## ARLINGTON COUNTY, VIRGINIA

### County Board Agenda Item Meeting of October 15, 2011

- SUBJECTS:**
- A. GP-316-11-2 General Land Use Plan Amendment to modify Note 20 to revise the amount of development density to be allocated to the Monument View Site Plan (SP #400) site area within the “North Tract Special Planning District” which is an area generally bordered by Shirley Highway Interstate 395 on the west, the George Washington Memorial Parkway on the north and east, and 10th Street South on the south.

- B. SP #400 Site Plan Amendment for Monument View to permit a 453,422 square foot office building in lieu of 352 dwelling units, 323,229 square feet of office and 3,512 square feet of retail, and a comprehensive sign plan in the C-O-1.5 Zoning District under Section 36.H of the Zoning Ordinance. Property is approximately 204,966 square feet, located at 550 South Clark Street, 320 6th Street South, 901 South Clark Street, 608 South Ball Street, and portions of South Clark Street. The density of the previously approved Site Plan is 3.32 FAR. The proposed density is 2.21 FAR. Modification of Zoning Ordinance requirements include: parking, signage and other modifications as may be

# Elevations: Sign type A1 & A2

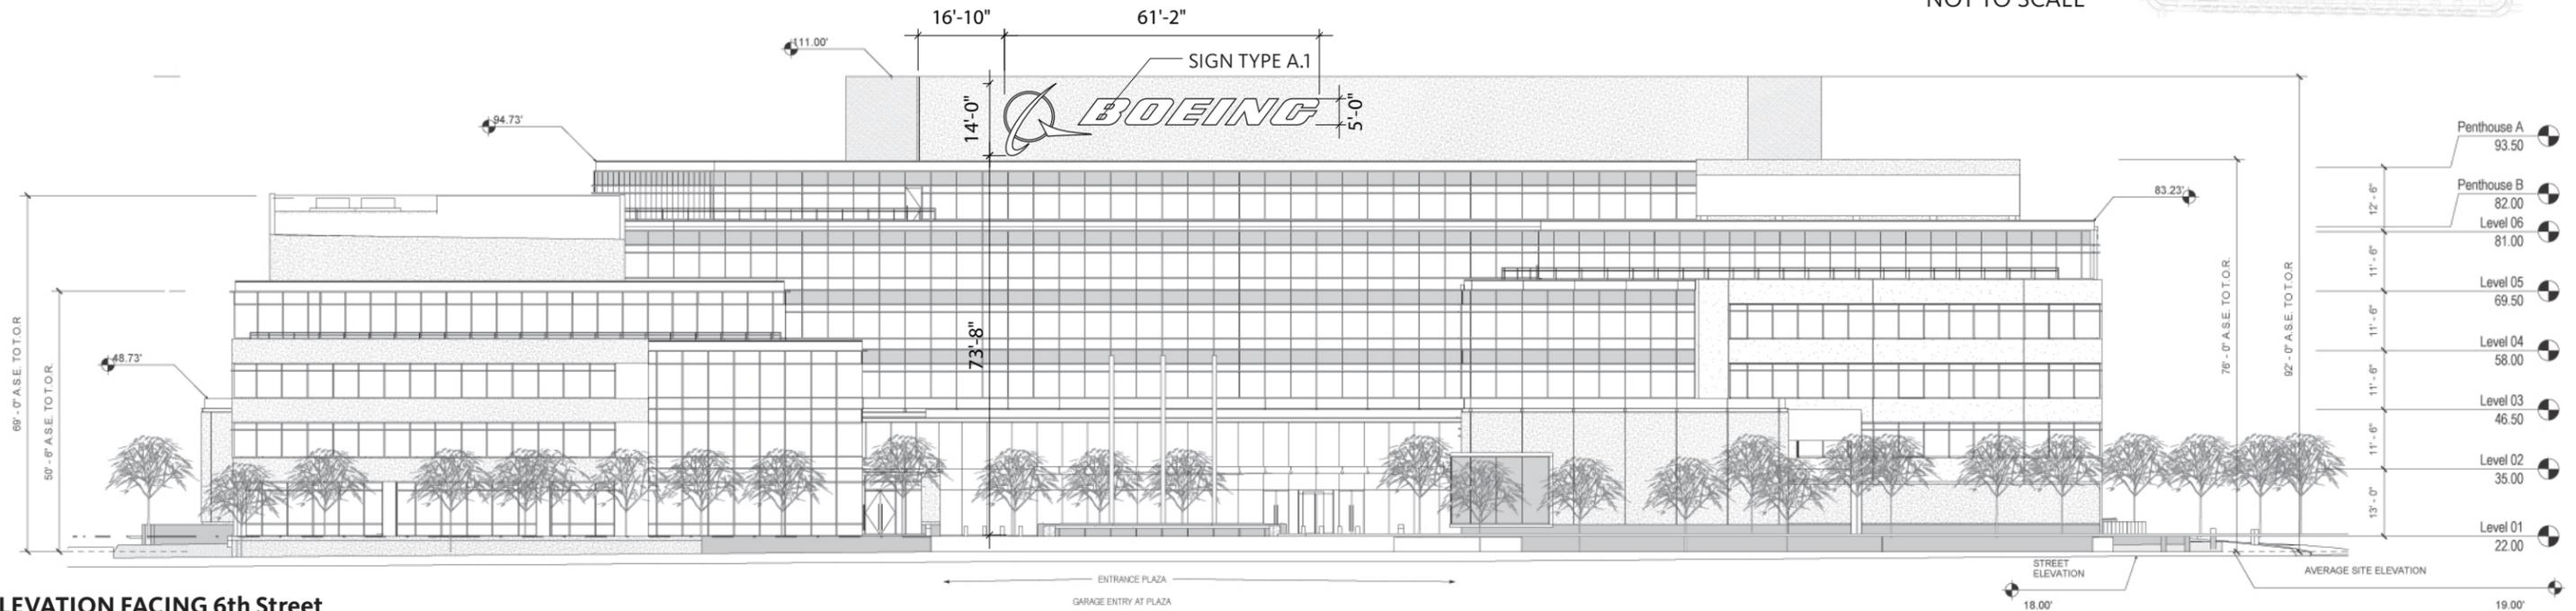
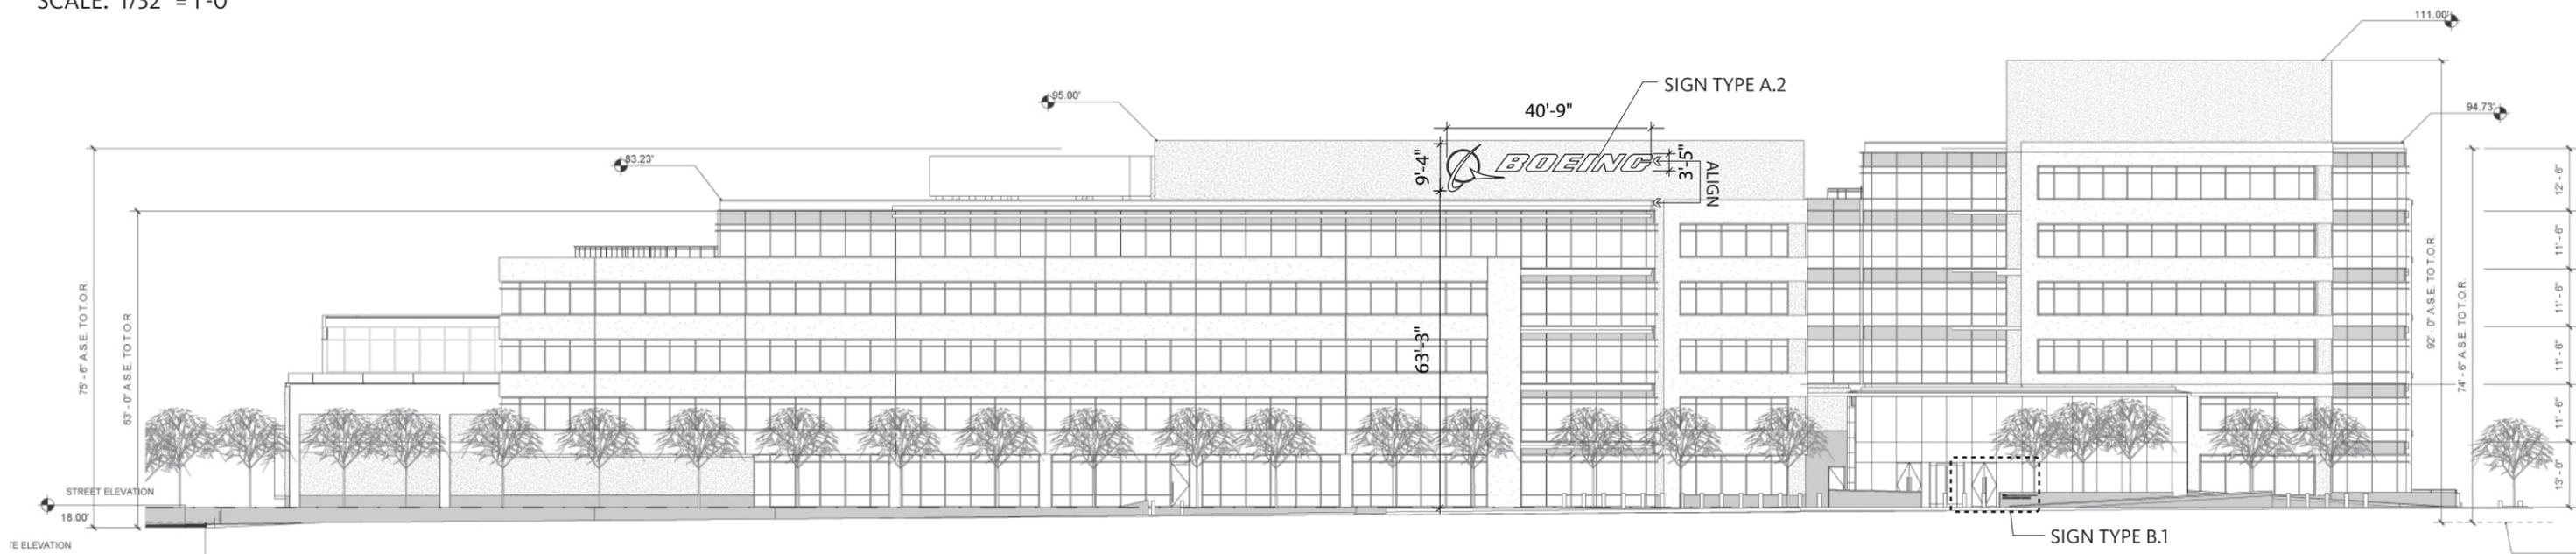
3. Remove the penthouse/rooftop sign on the north facade and condition that any illumination be reviewed by the County and stakeholders after implementation.

- *Staff Response:* Though not commonly located on penthouses, there are many buildings throughout the County's Metro corridors with rooftop signs located on the penthouse. As proposed, the rooftop signs will allow for these signs to be visible to the public without obstructing views to the outside from the sixth story (uppermost floor) of the office building. In addition, Condition #49 has been proposed that will limit the hours and intensity of illumination of these rooftop signs, as well as the ability for the County

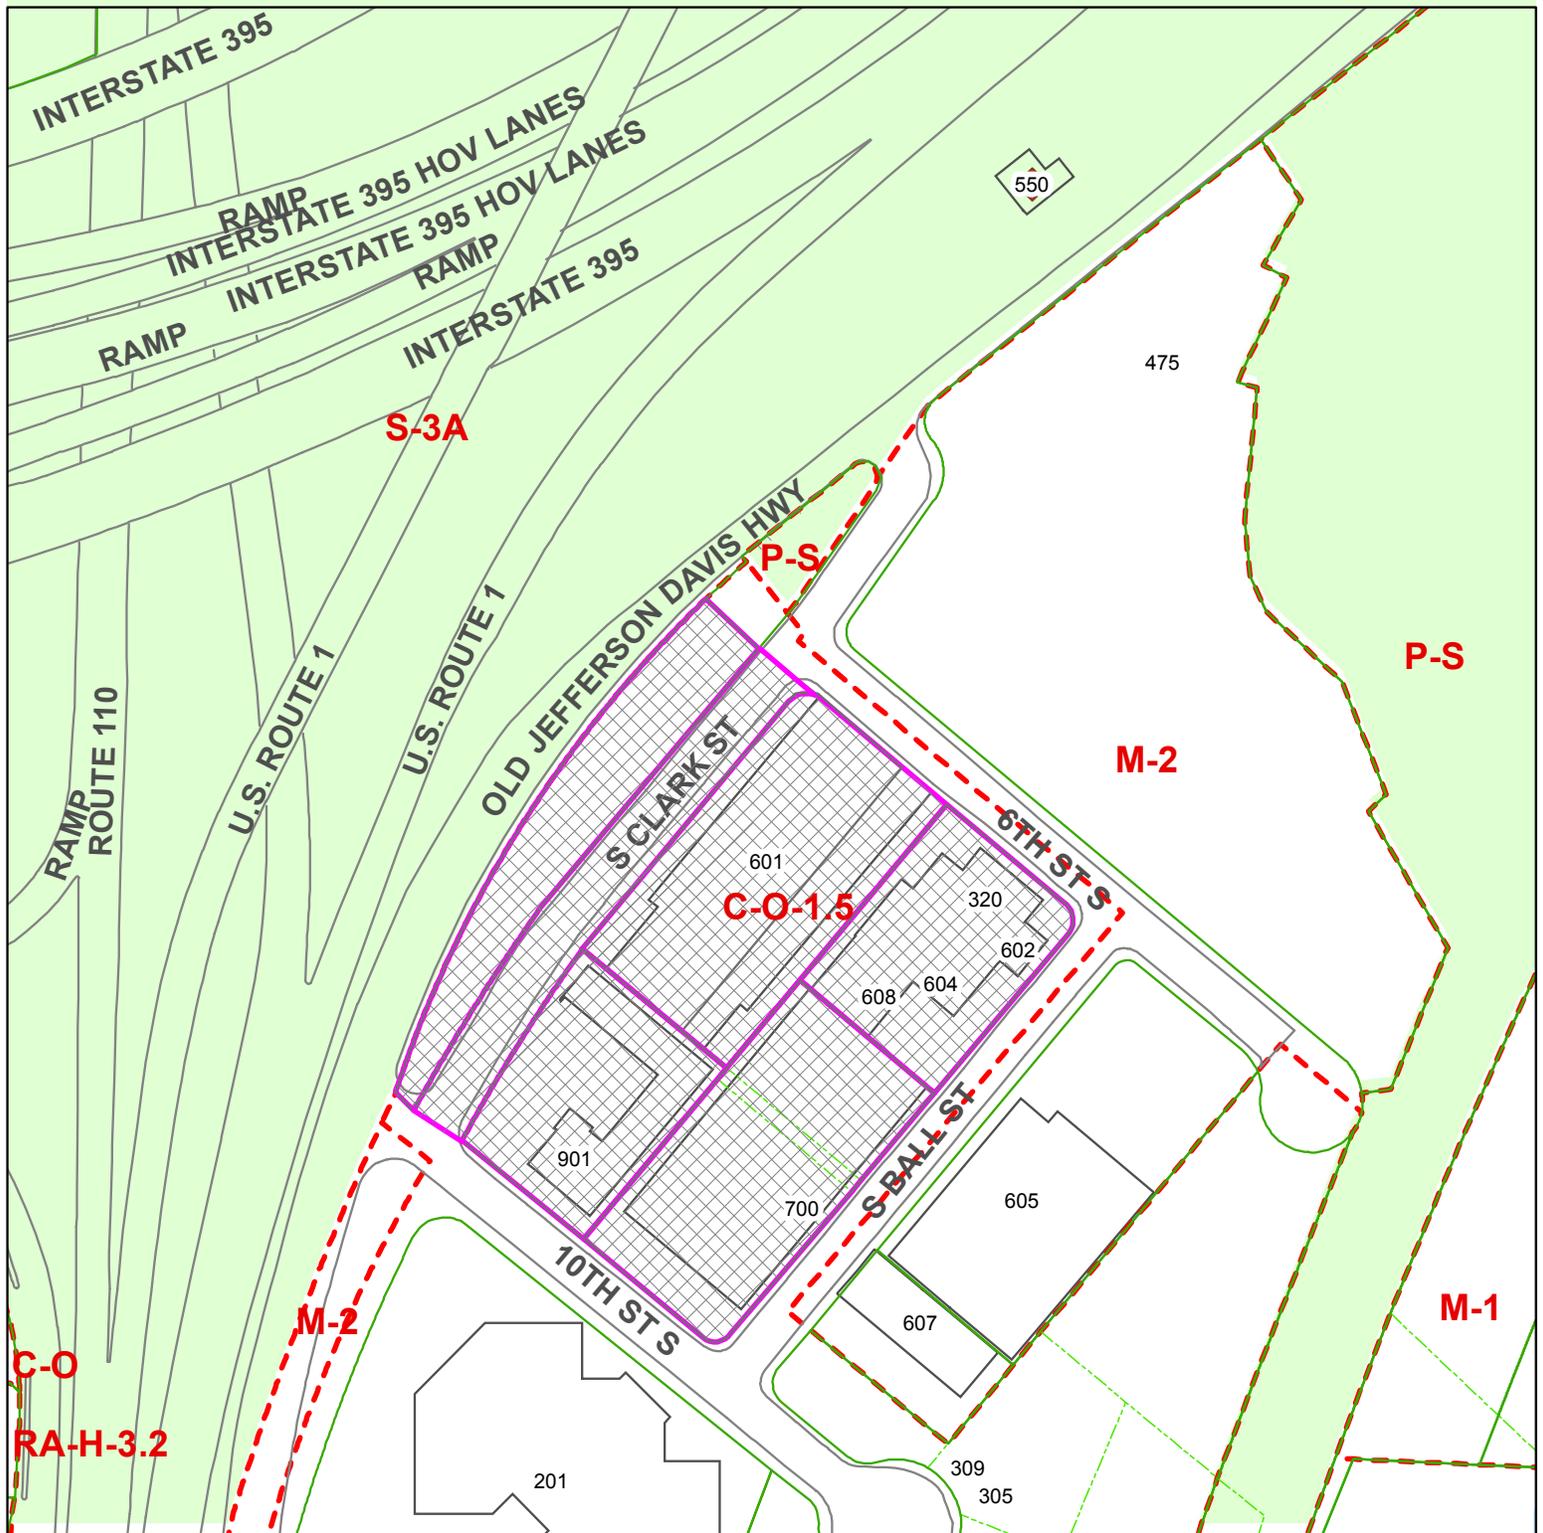
- Increase seating with moveable chairs to accommodate different seating arrangements and attract users. The flexible seating arrangements will be enjoyed by employees as well as by the general public and park users.

- Utilize the Silva Cell pavement supporting system for the trees surrounded by pavement. This system increases non-compacted soil space for the street trees. Shade for public comfort is important and adequate soil volume will ensure that the tree's can grow into the tall, canopy trees envisioned by the designers.

Activation of the 6<sup>th</sup> Street public space is important because this space is directly adjacent to Long Bridge Park and park users as well as employee needs should be addressed. As currently designed, the public space will be attractive but ultimately unused, "dead" space. There is nothing but a few angled benches to seat on and a floor plaque to read. The proposed vender will help but cannot be considered a permanent feature. Fortunately, the proposed shade trees will provide comfort but they need to have more soil volume to sustain tree health and height.
